Company	Trenz Electronic GmbH
PCN Number	PCN-20190108
Title	TE0807-02-* SPI Flash Change
Subject	BOM change
Issue Date	2019-07-08

# #1 Change SPI Flash from N25Q512A11G1240E to MT25QU512ABB8E12-0SIT

Locate Flash (U7, U17) on bottom side of PCB:

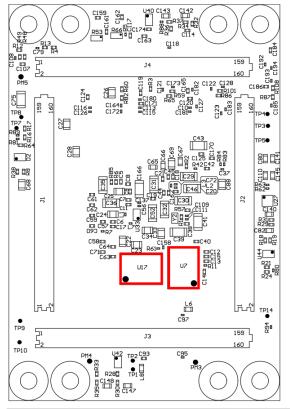
Type: BOM change

Reason: N25Q512A11G1240E became obsolete.

Impact: None. Both have same JEDEC ID BB20h and manufacturer ID 20h.
